VERMONT YANKEE NUCLEAR POWER CORPORATION

February 2, 1990
BVY 90-011

Subject: Response to Request for Additional Information Regarding the Topical Report
YAEC-1683 on MICBURN-3 / CASMO-3 / TABLES-3 / SIMULATE-3
Benchmarking

RESPONSES TO REQUEST FOR ADDITIONAL INFORMATION CONCERNING YAEC-1683,
MICBURN-3/CASMO-3/TABLES-3/SIMULATE-3 BENCHMARKING OF
VERMONT YANKEE CYCLES 9 THROUGH 13

Figure 1.1

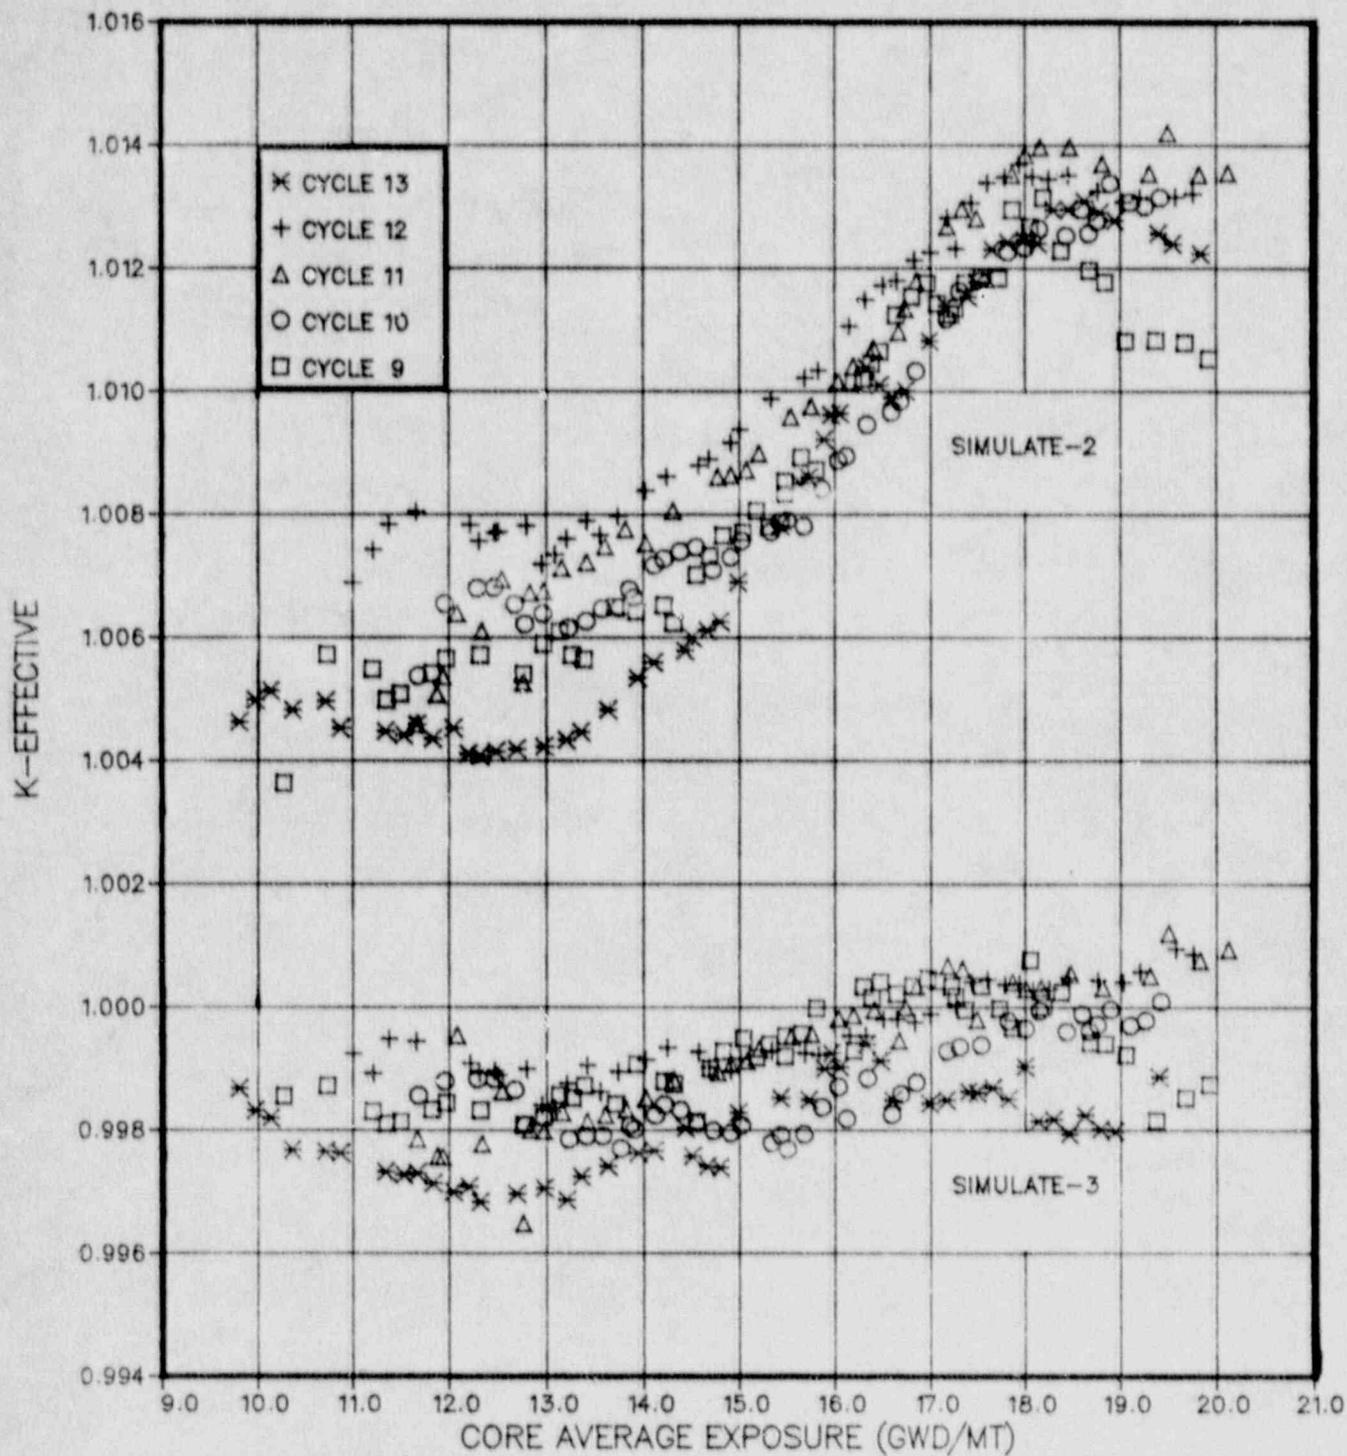
1) **Q. How will the reduced K_{eff} uncertainty impact the YAEC Licensing Analyses?**

A. On Table 5.7 of YAEC-1683, the hot eigenvalue standard deviation is reduced from $\pm .00281$ with SIMULATE-2 to $\pm .00098$ with SIMULATE-3. Most of this improvement with SIMULATE-3 is caused by a reduction in eigenvalue drift with exposure. As Figure 1.1 illustrates, both SIMULATE-2 and SIMULATE-3 track along well defined paths. It is the consistent behavior of the hot model's eigenvalue path which provides confidence in the predictions made during the licensing (e.g., end of cycle exposure, critical rod patterns for initiating transients, etc.). Since both models have well defined pathways, the hot portion of the licensing will not be affected by this reduction in hot K_{eff} uncertainty.

Figure 7.1

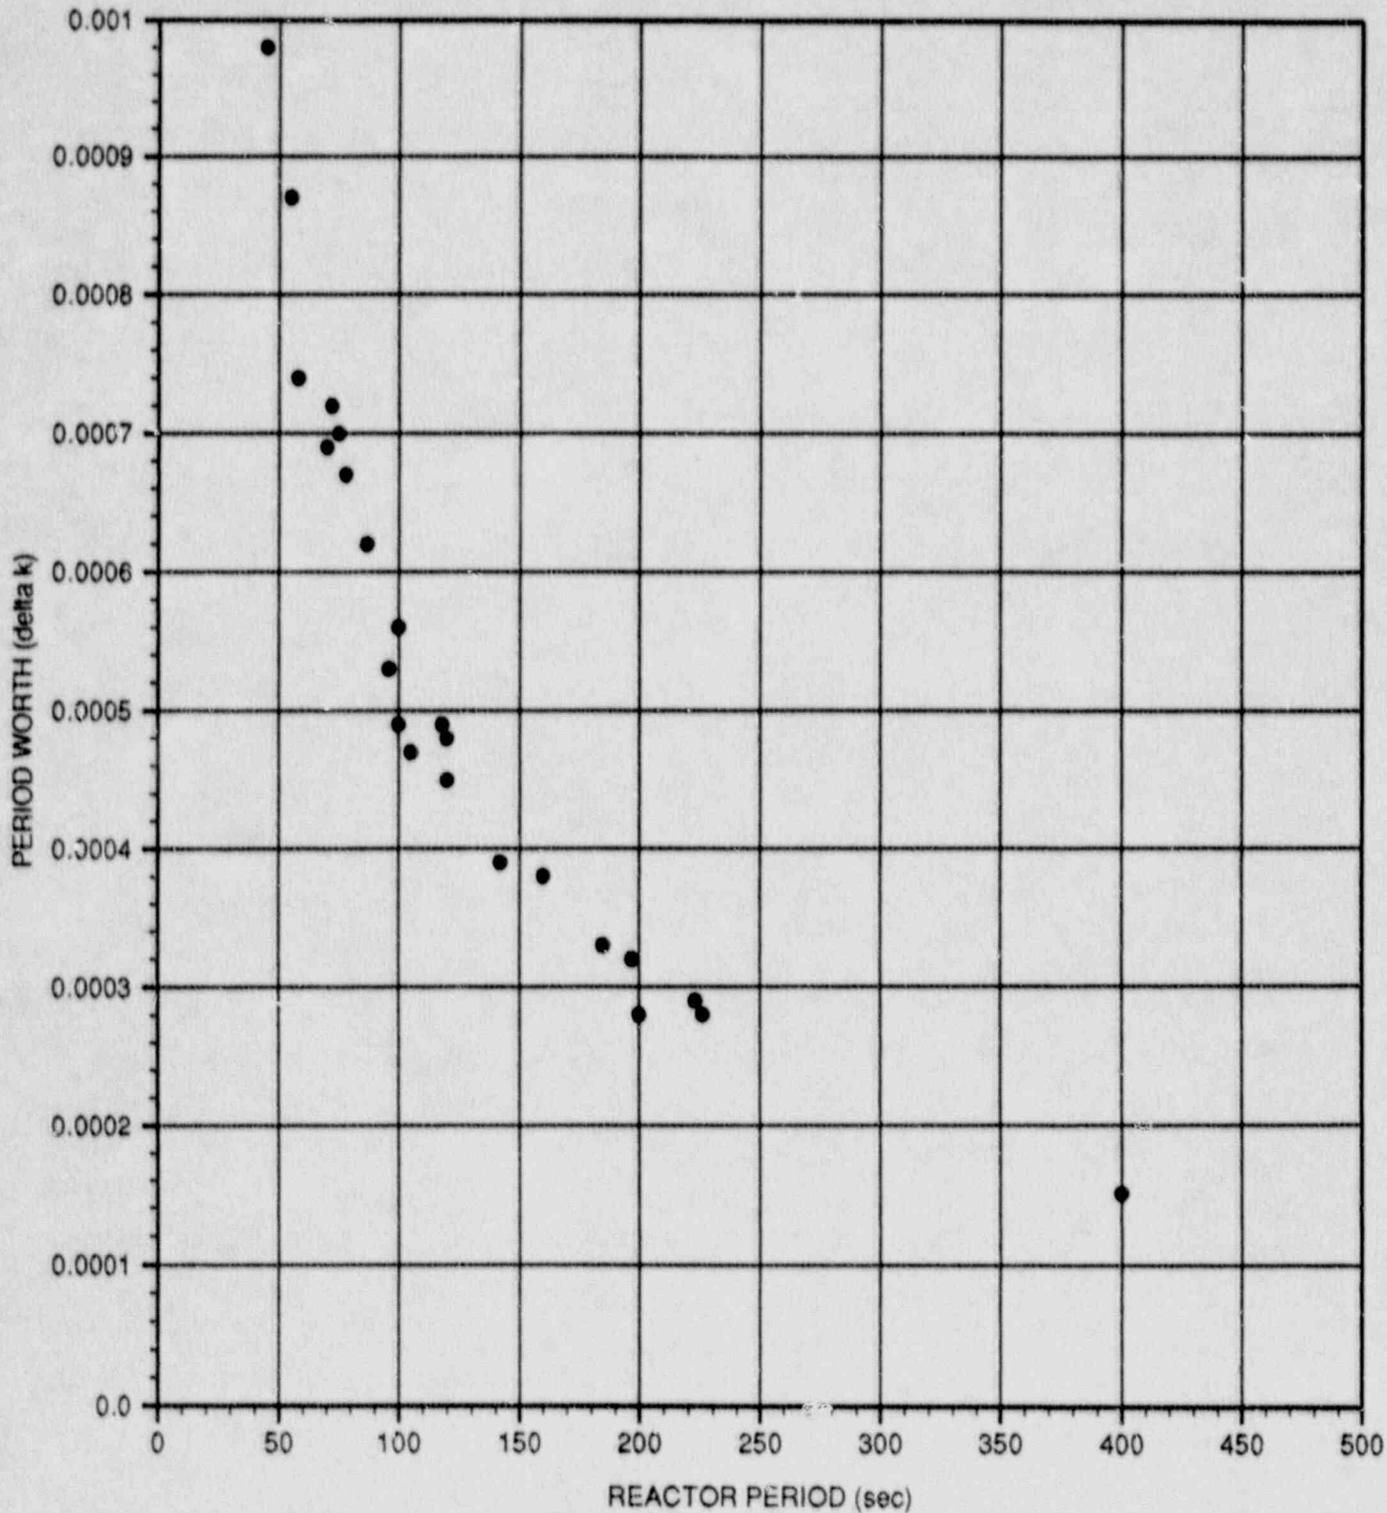
7) Q. **How was the reactor period converted to reactivity in the cold-critical measurements?**

A. The reactivity correction ($-\rho$) for reactor period (T) was calculated using the in-hour equation. For large periods, the in-hour equation reduces to:

$$\rho = \sum \frac{\beta_i}{1 + \lambda_i T}$$

The six group β_i and λ_i point kinetics parameters are generated during the licensing of each cycle. The values of β_i change slightly from cycle to cycle, and change with exposure within a given cycle. The use of cycle and exposure specific values for β_i causes some variation in the period corrections used in the benchmark. These are plotted versus stable reactor period in Figure 7.1.

Simple Model For Channel Powing

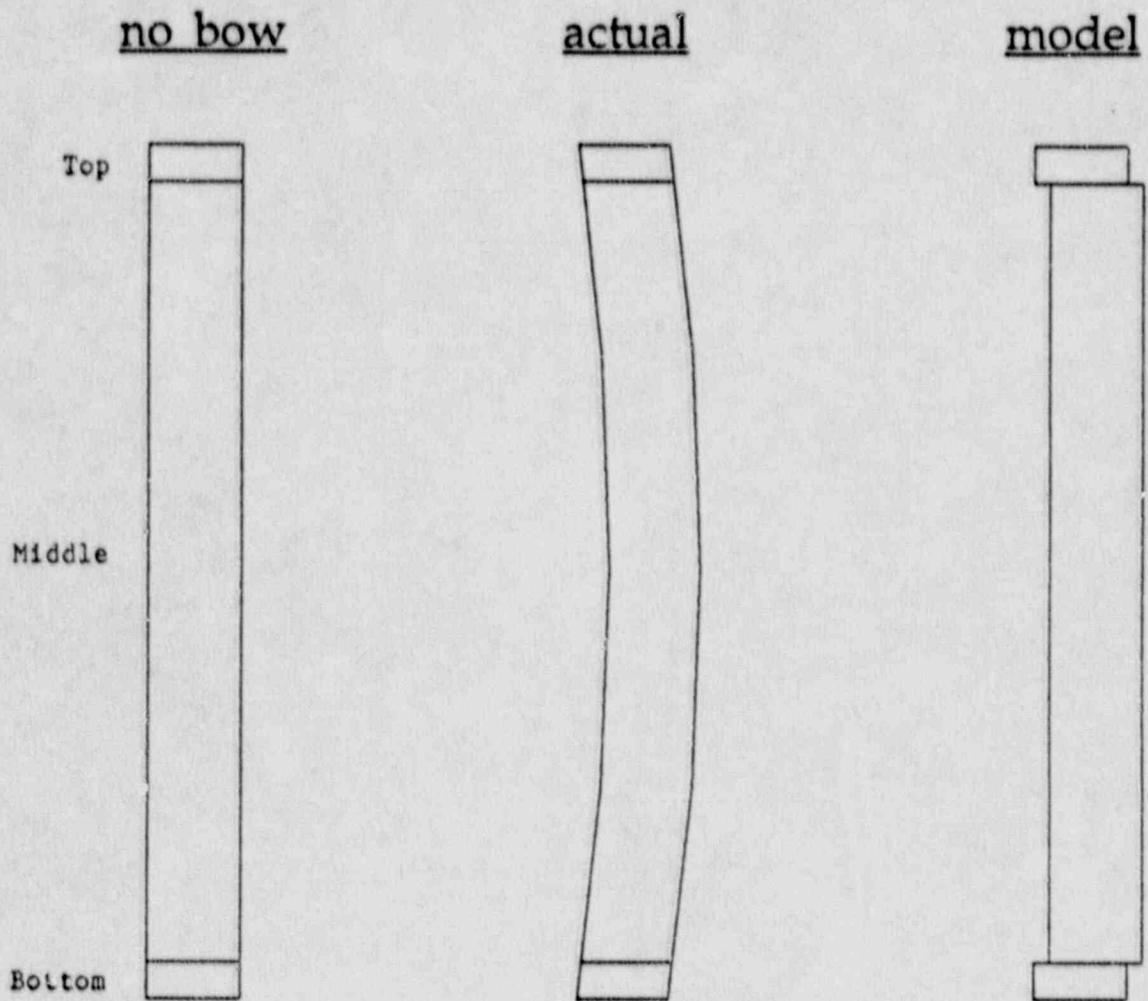
9) Q. **What axial and radial distribution of channel-bow was assumed in the Vermont Yankee calculations? What was the basis for this distribution and did it depend on fuel burnup?**

14) Q. **Provide a detailed description of the technique used to incorporate the results of the CASMO-3G calculations for the bowed-channel bundles in the CASMO-3G/SIMULATE-3 model. In addition to the deflection of the channel walls, are the fuel pins in the lattice also assumed to be displaced? How are the effects of channel-bowing on fuel rod power peaking accounted for?**

Effect (a) is implemented in the model by having the entire lattice, pins and all, deflected in CASMO-3G by the amount of bow. This is achieved in CASMO-3G by simply adding to the dimensions of the wide water gap, while subtracting an equal amount from the dimensions of the narrow gap. Since the pins keep the same geometry relative to the channel walls, they have effectively moved with the channel-bow.

Effect (c) is partially implemented by using an amount of channel bow which is greater than the as-manufactured average bow (approximately 30 mils). As stated in Appendix C of YAEC-1683, a value of 40 mils was arbitrarily selected by the investigators to approximate the core average channel bow. Thus, some amount of increase due to burnup is included in the model. However, further change in bow during the cycle is not modeled. The amount of bow is kept fixed for the lifetime of the lattice.

Effect (d) is not included: A detailed axial shape was omitted to keep the model simple. The middle lattices of each fuel type are modelled in CASMO-3G with the same deflection for the 0%, 40% and 70% void depletion cases and branches. Figure 14.1 shows what the effective axial representation of the bowing is in the model. For axially zoned fuel, the top and bottom fuel zones are assumed to have no deflection. All middle fuel zones are run in the CASMO-3G model as if they were uniformly deflected by the full amount of the assumed bow.

To summarize the answer to Question 9, based on the details provided above: The axial and radial distribution of channel-bow in the model is uniform. The amount of bow (uniform deflection) modelled is arbitrarily set at 40 mils. This amount of bow exceeds the as-manufactured amount; therefore, some of the increase in channel-bow with burnup is included in the model. However, the assumed amount of deflection in the model remains fixed during the cycle.
